**SAND CREEK - CENTER TRIBUTARY
CHANNEL ANALYSIS REPORT
FOR
SOLACE APARTMENTS**

**May 1, 2020
Project No. 25174.00**

**Prepared By:
JR Engineering, LLC
5475 Tech Center Drive
Colorado Springs, CO 80919
719-593-2593**

PCD File NO. SP201

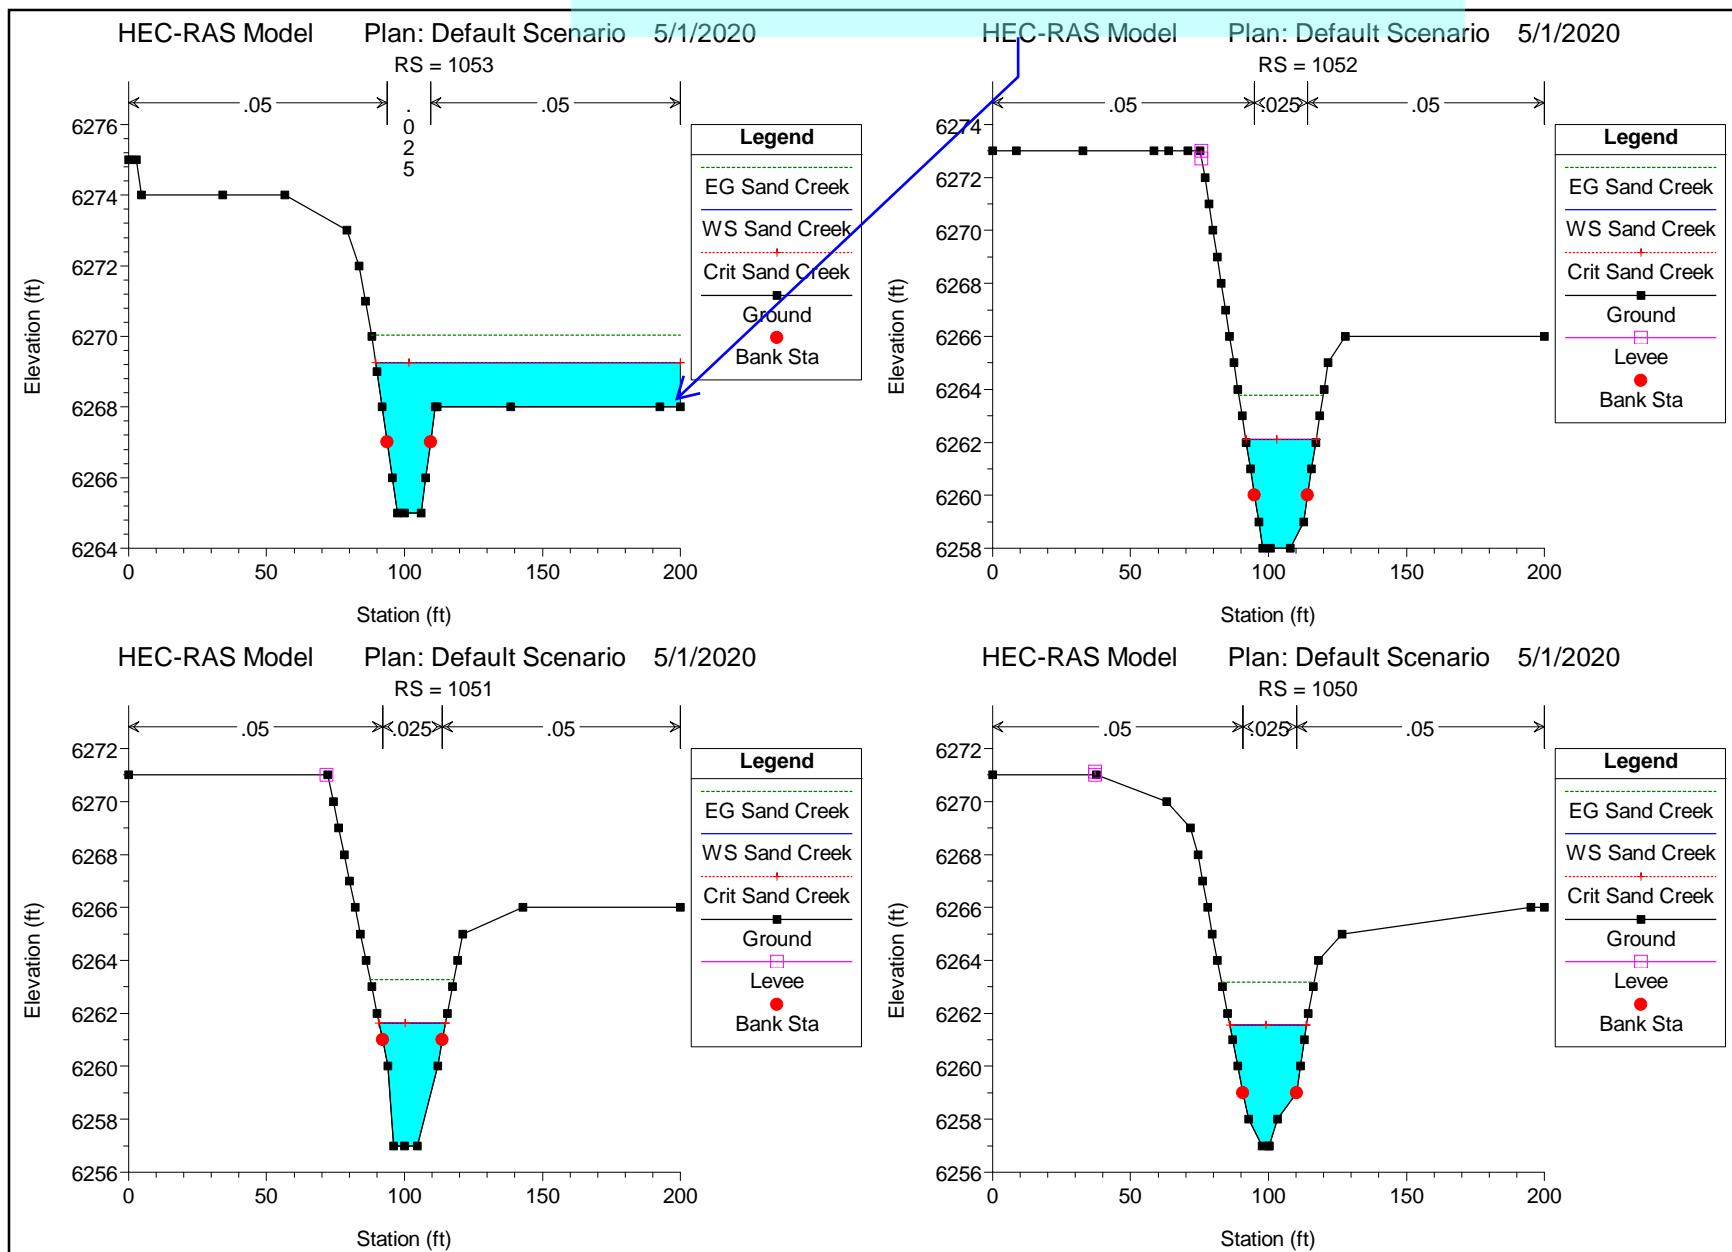
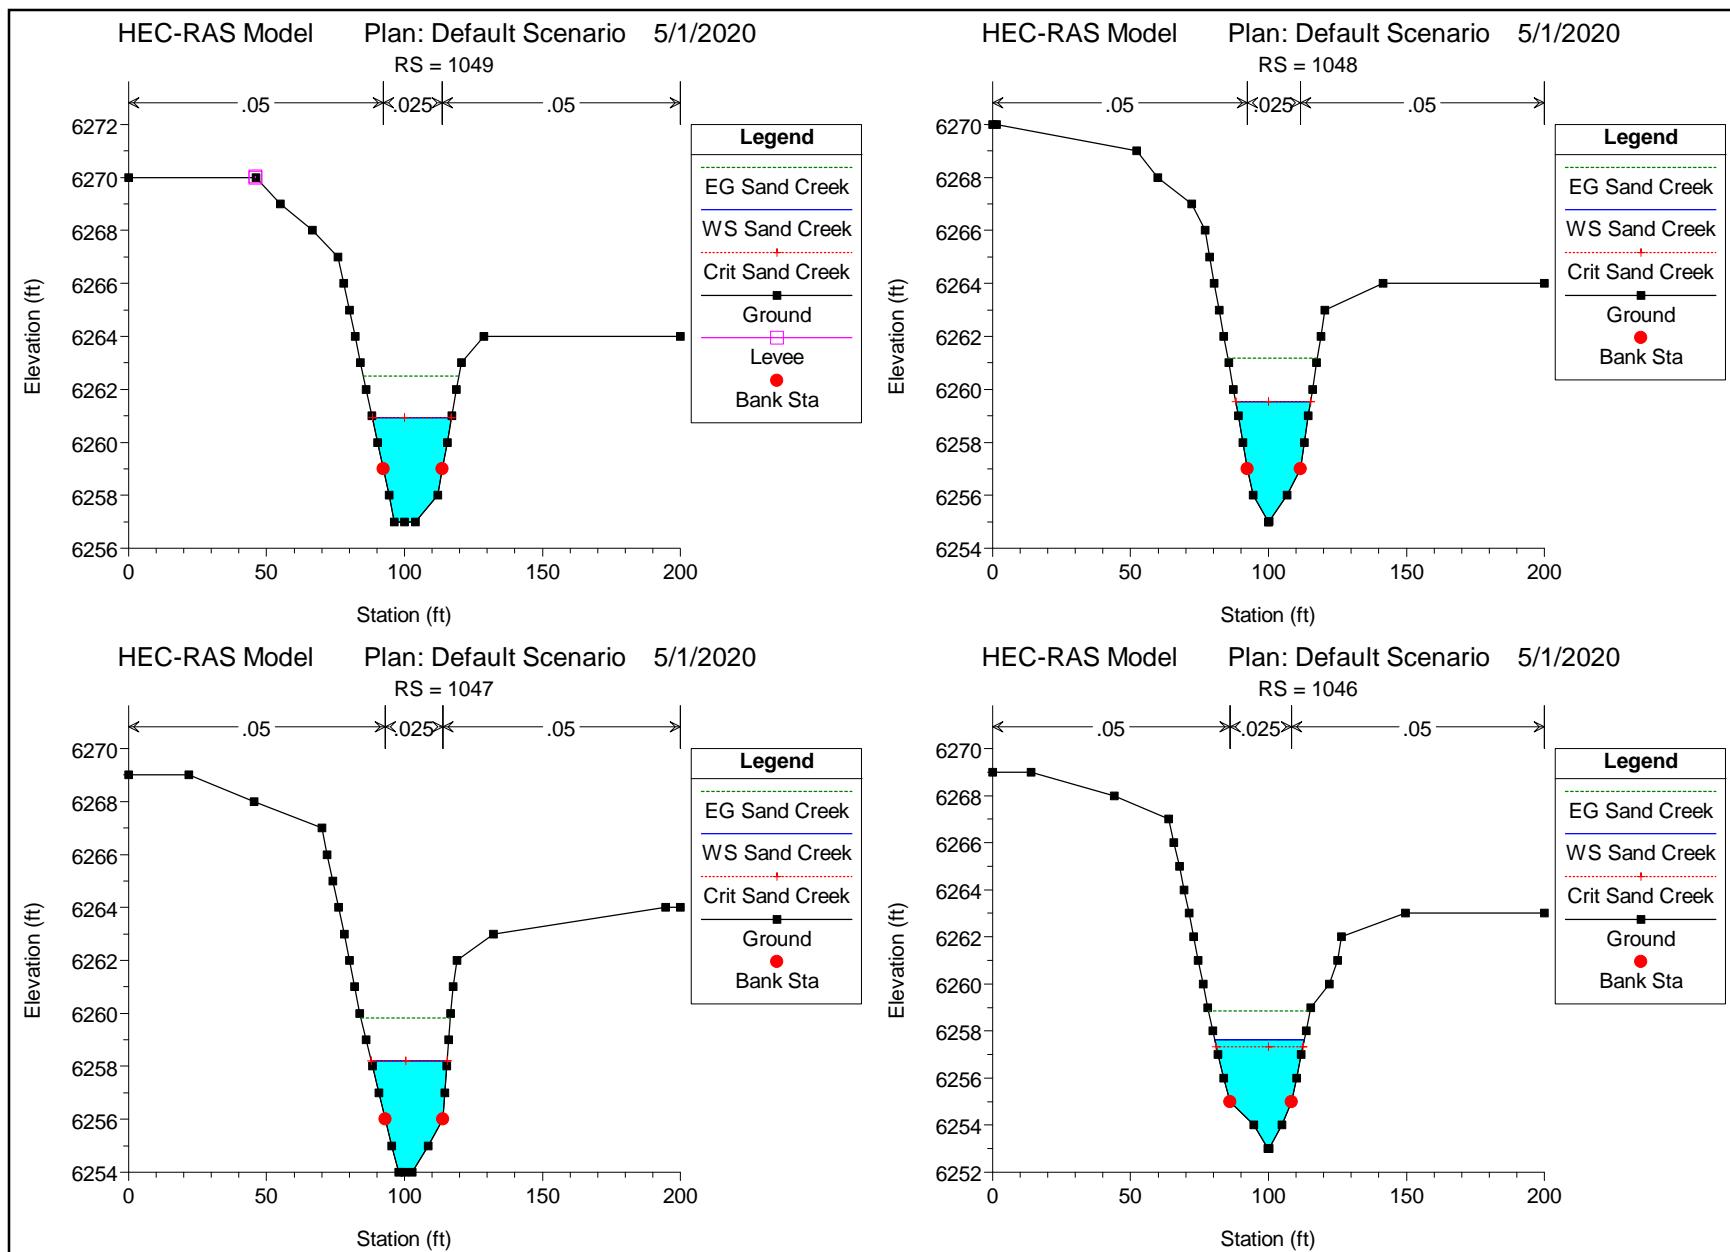
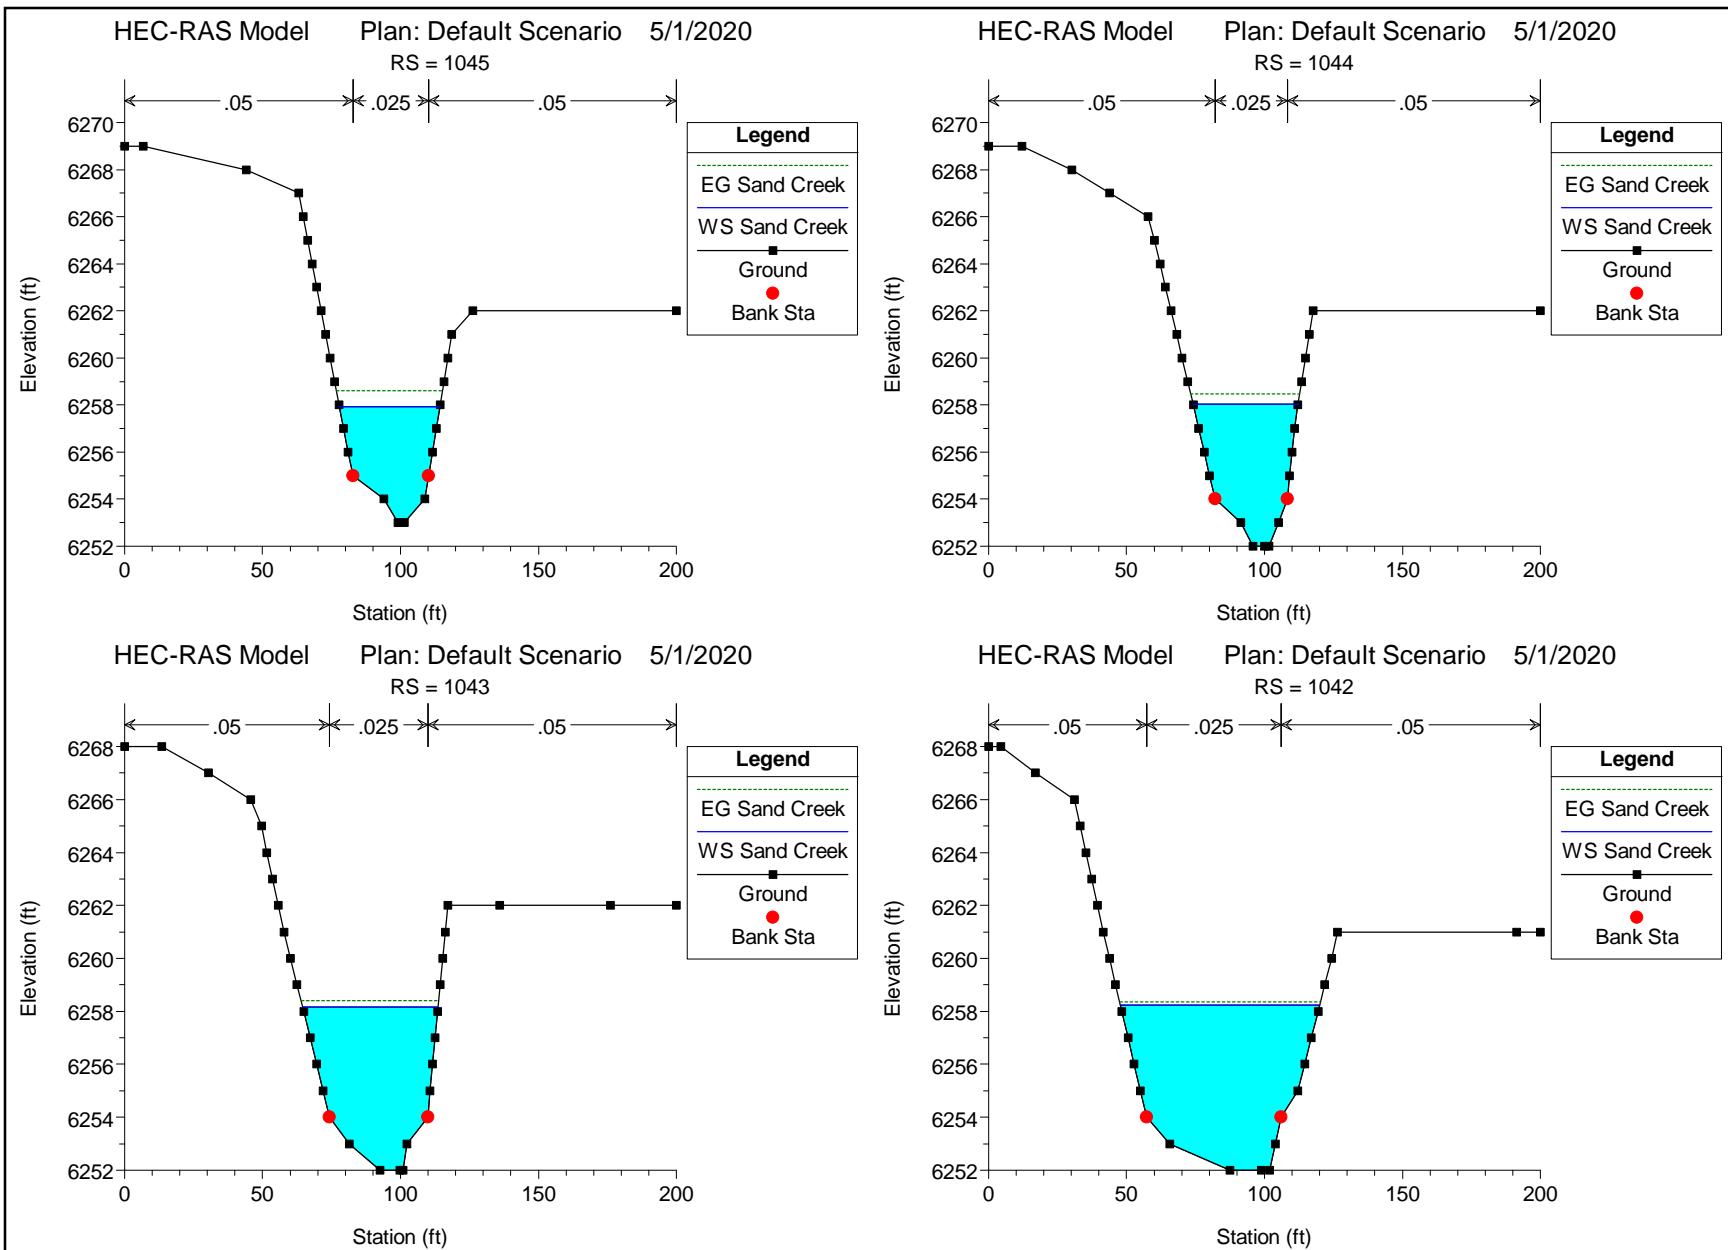
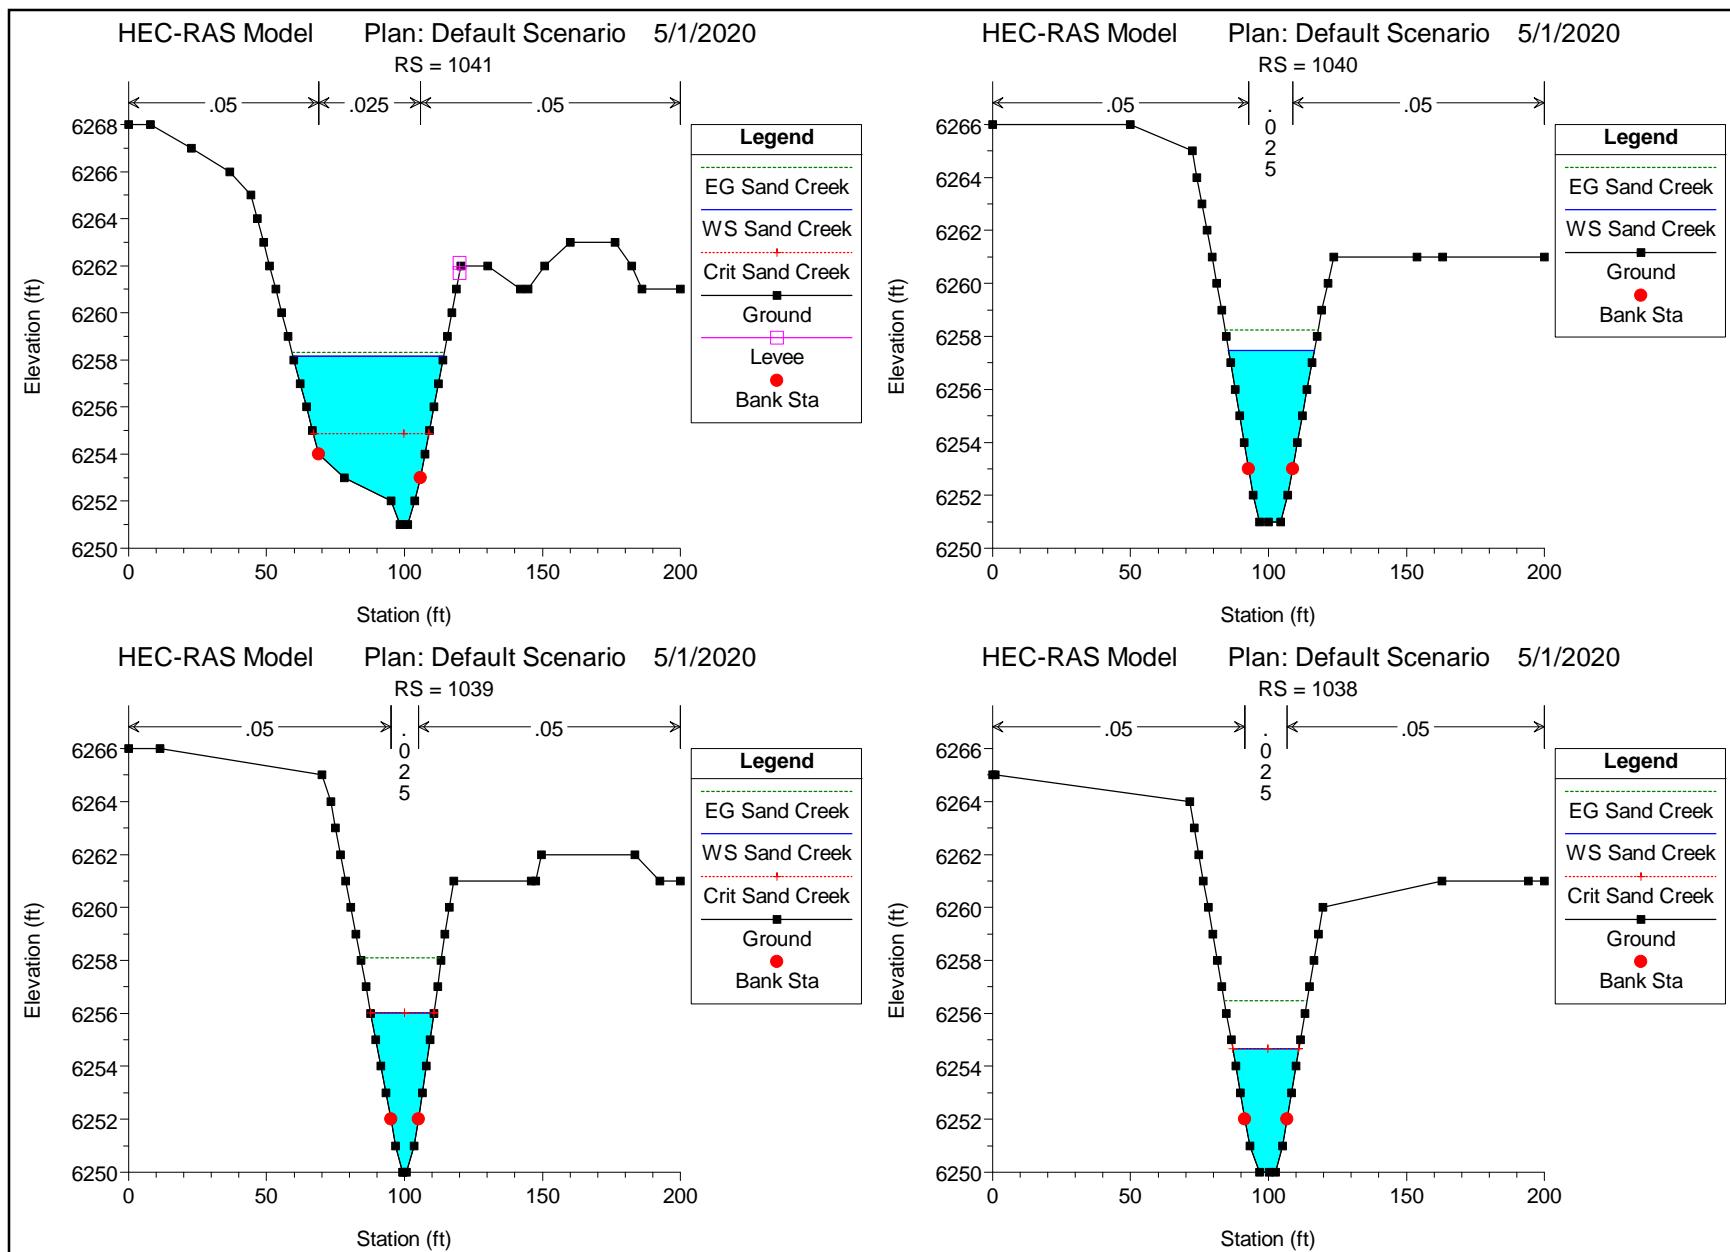
Extend the cross section further out. The hydraulics does not appear to provide an accurate representation of the existing conditions/extend of the 100yr flow
